RESPONSE TO NRC QUESTIONS
RADWASTE MODIFICATION
OYSTER CREEK NUCLEAR POWER STATION

December 1975

**EVALUATION OF LIQUEFACTION
POTENTIAL DURING SSE ($a_{max} = 0.22 g$) USING N VALUES
FROM BORINGS BENEATH RADWASTE BUILDING**

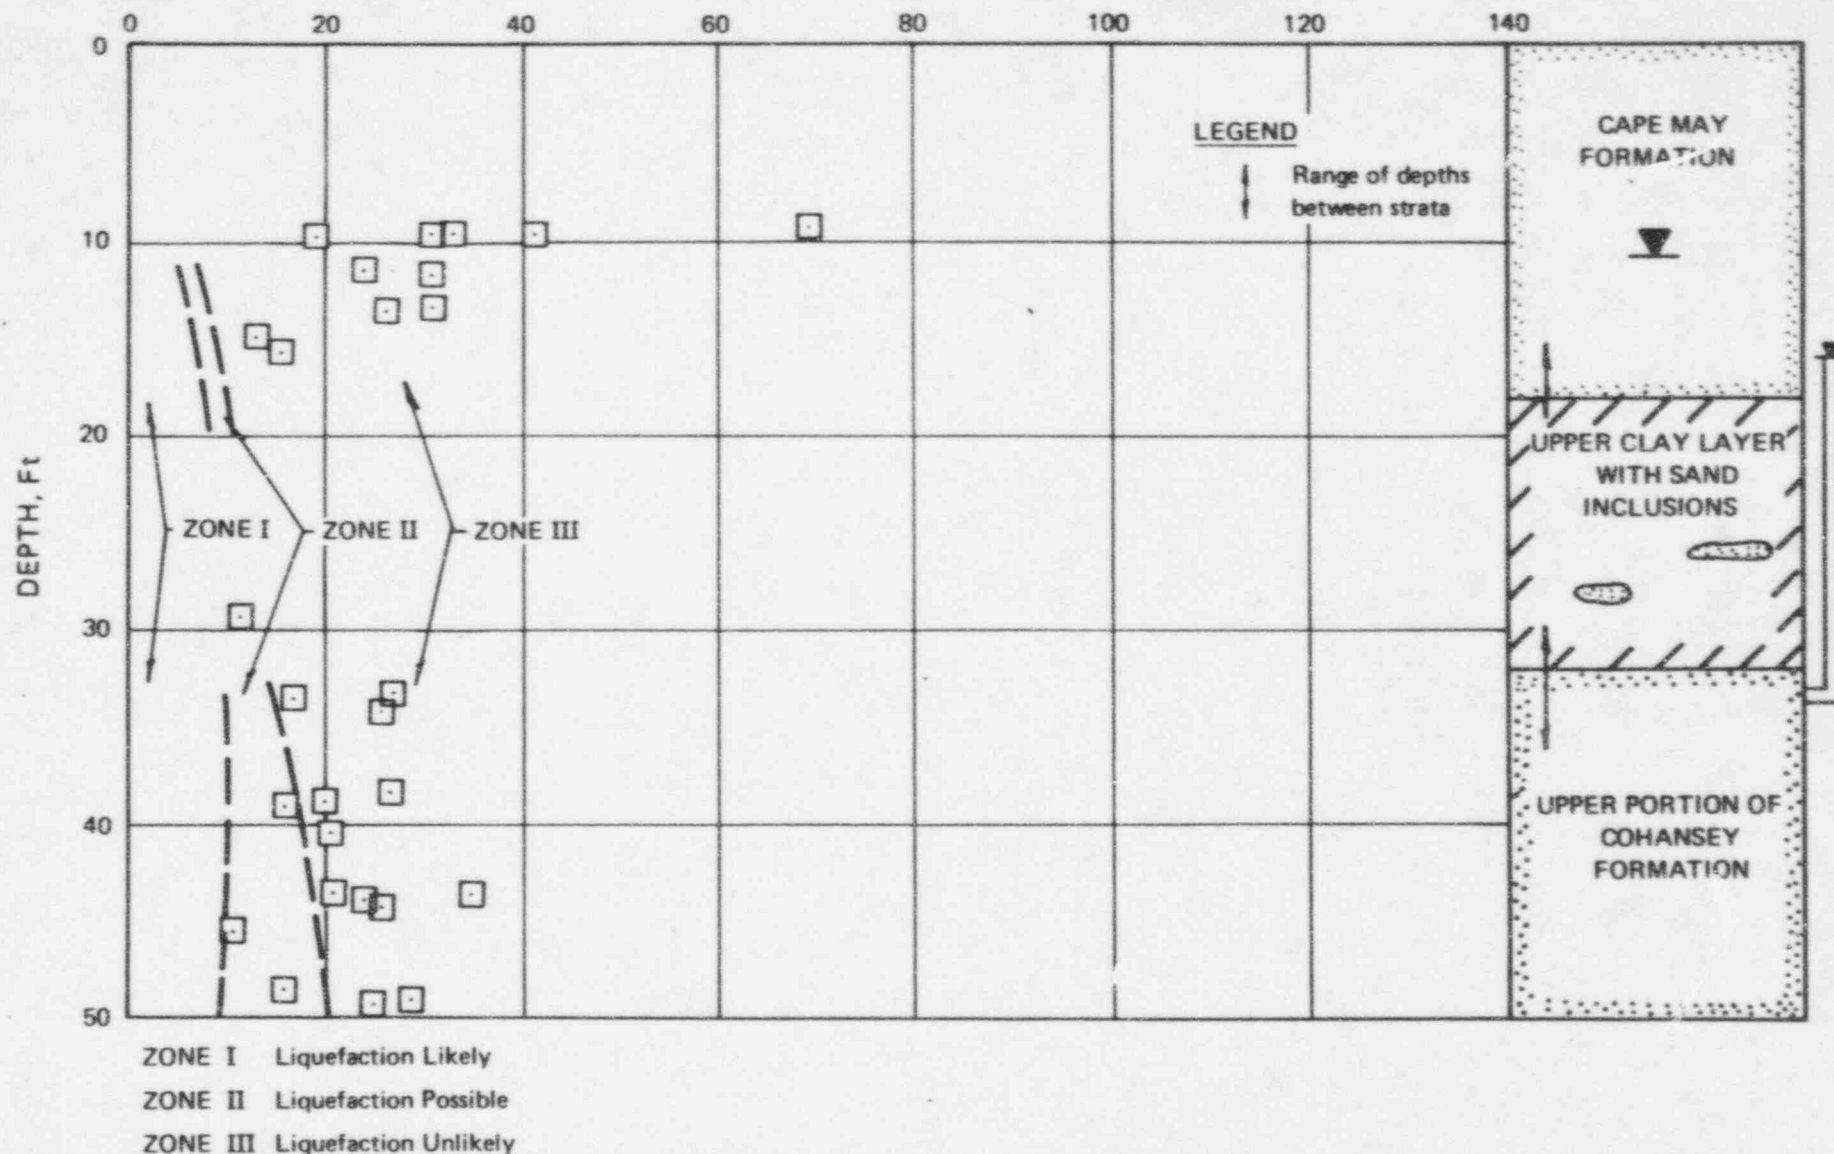
We agree that much of the data presented to interpret liquefaction case histories was obtained by means of the SPT. However, as indicated in our response to the previous question, we believe that the properties (relative density and cyclic undrained shear strength) of undisturbed samples provide a more reliable basis to judge liquefaction potential than does evaluation based on N-values. This opinion appears to be consistent with the current position of NRC; refer to NRC Standard Review Plan, Subsection 2.5.4.8, dated June 1975.

point falls within Zone II, and that is very close to the boundary of Zones II and III; refer to Fig. 324.1.1. Furthermore, as indicated previously, we believe that data obtained from borings made outside the plan limits of the proposed building should also be included in the liquefaction evaluation, since the geologic histories of the deposits, both within and outside of the proposed building limits, are the same. We say this despite the fact that most of the less favorable SPT data were obtained in borings located outside of the proposed building limits. Considering all the data, only few data points were plotted in Zone II where liquefaction can be considered as possible; refer to Fig. 324.1.2. At the time we were making our evaluation of liquefaction potential during the SSE, we interpreted the data plotted in Fig. 324.1.2 to indicate that a more detailed analysis was required and, therefore, we made a quantitative evaluation of liquefaction potential of the upper portion of the Cohansey Formation based on stresses determined in a response analyses and strength based on cyclic triaxial tests involving undisturbed samples.

RESULTS OF CONSOLIDATION TESTS -- UPPER CLAY LAYER

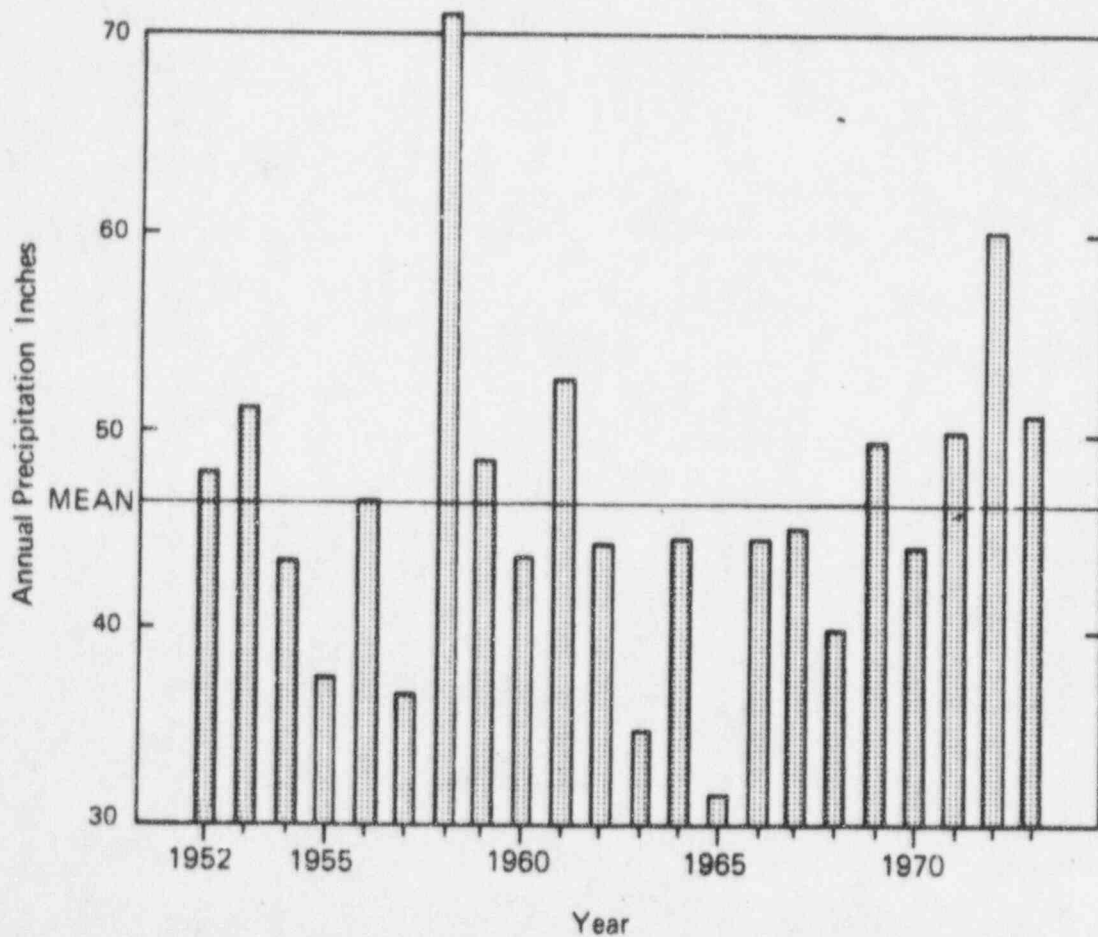
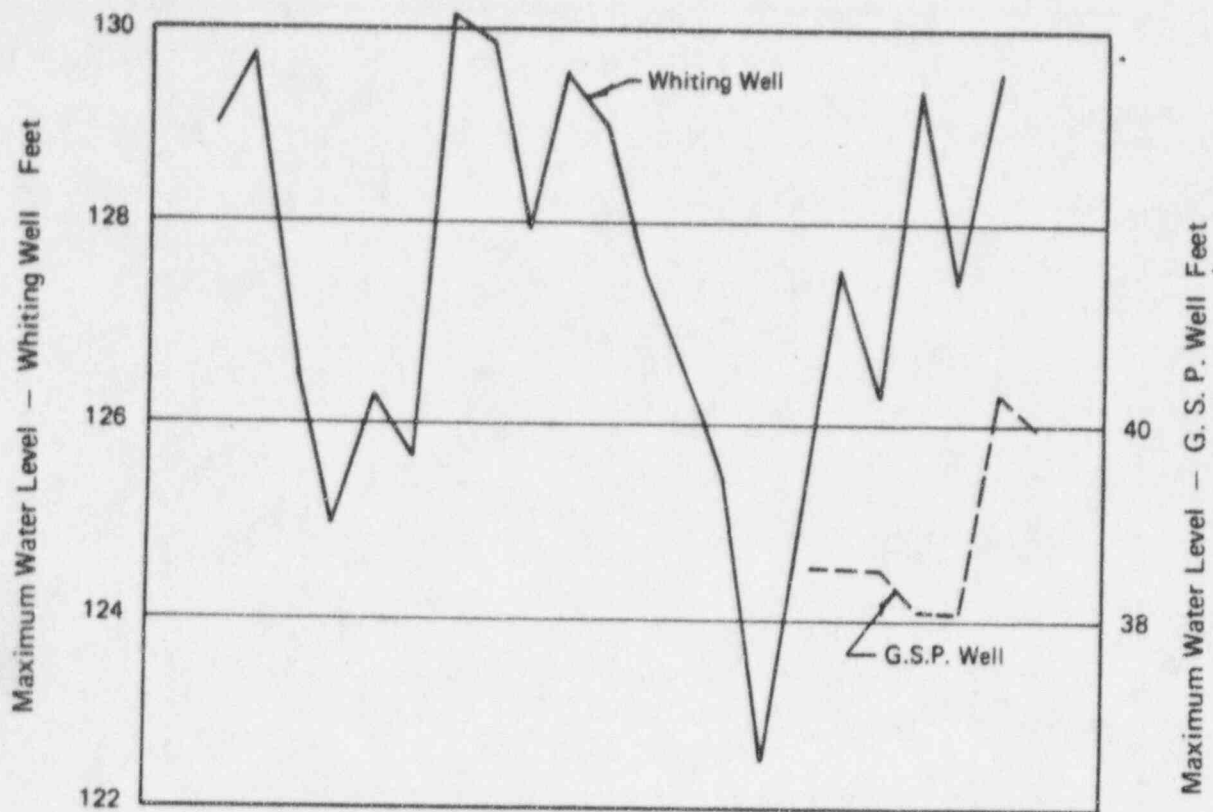
"You have not provided sufficient evidence to support your conclusions regarding the previous loading of the clay in the upper clay formation. Only one consolidation test is provided for materials under the Radwaste Building. Provide additional data to support your evaluation of previous loadings."

We conclude that the Upper Clay Layer is heavily overconsolidated. The results of the three consolidation tests performed on samples of the layer are very similar even though they were obtained at different locations. These test results provide sufficient data to evaluate the compressibility of the Upper Clay Layer, including the portion that underlies the site of the proposed Radwaste Building.

FIG. 324.8.1

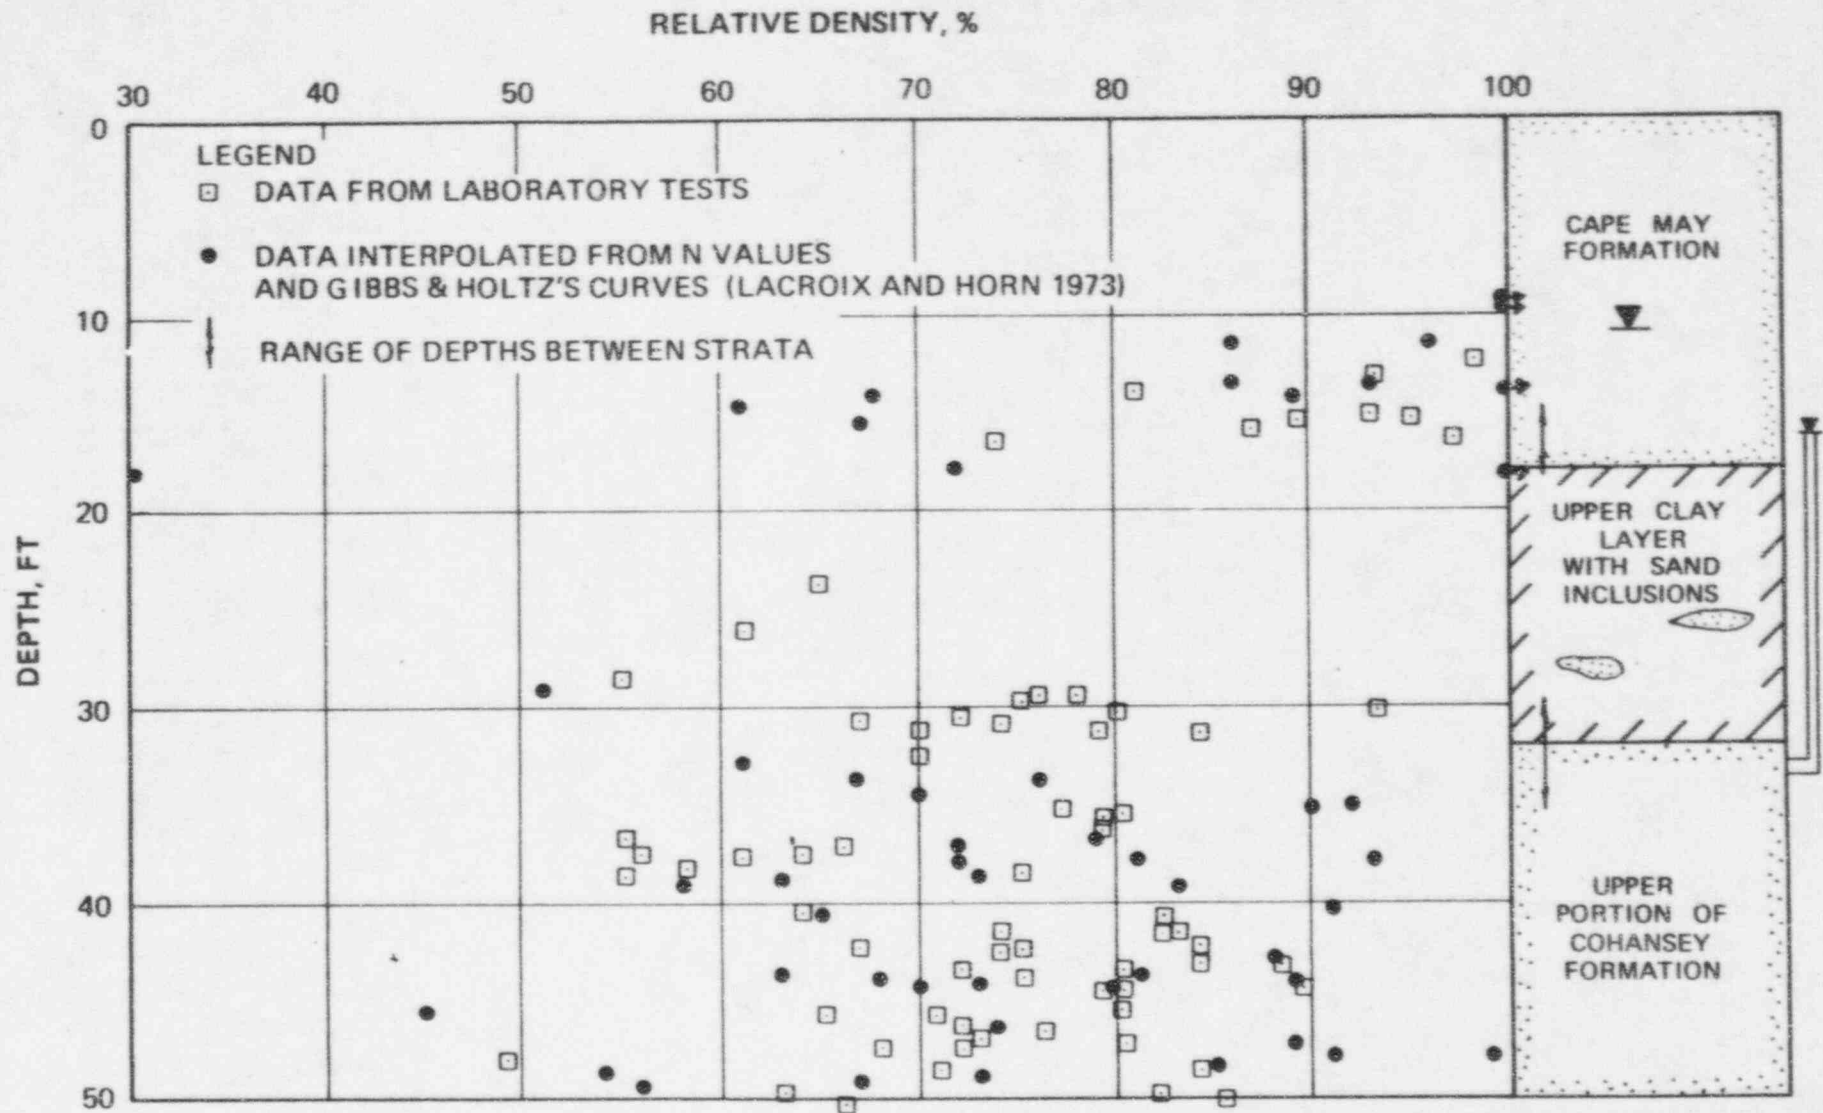
"Discuss the possibility of the groundwater level increasing during the life of the plant, and the effect on the liquefaction potential."

The main recharge area for the Cohansey is to the northwest of the plant site in the Pine Barrens. The USGS has an observation well in Whiting, New Jersey, approximately 10 miles from the plant site, which is completed in the Cohansey. Continuous water level records have been obtained from this well since 1952 (see Fig. 342.8.1). Between 1952 and 1972 inclusive (21 years of record), the total water level fluctuation was 8.75 ft, and the maximum 1972 water level was only 0.63 ft less than the maximum level recorded in that well. Another USGS observation well, located near the Garden State Parkway, is approximately two to three miles from the plant site. Water levels have been measured sporadically in this well since 1967 (see Fig. 324.8.1). Between 1967 and 1973 inclusive, fluctuation was 2.22 ft (compared with 4.22 ft for the Whiting Well for the same period) and the maximum water level for the period was recorded in 1972. The maximum water level for 1973 was only 0.42 ft less than that for 1972. The rainfall for 1972 was approximately 15 in. above the mean (see Fig. 324.8.1), while the rainfall for 1973 was less than that for 1972, but still well above average. Piezometer P1, which was installed in 1973, has, during a period of over one year, fluctuated very little (about 1 ft; ie, between el 6 ft and el 7 ft). The records of the two USGS observation wells indicate that the maximum piezometric level in the Cohansey Formation in 1973 was within about 1 ft of the maximum level recorded since 1952. The rainfall records suggest that the 1972 piezometric level is probably within about 1 ft of the maximum level since 1952.
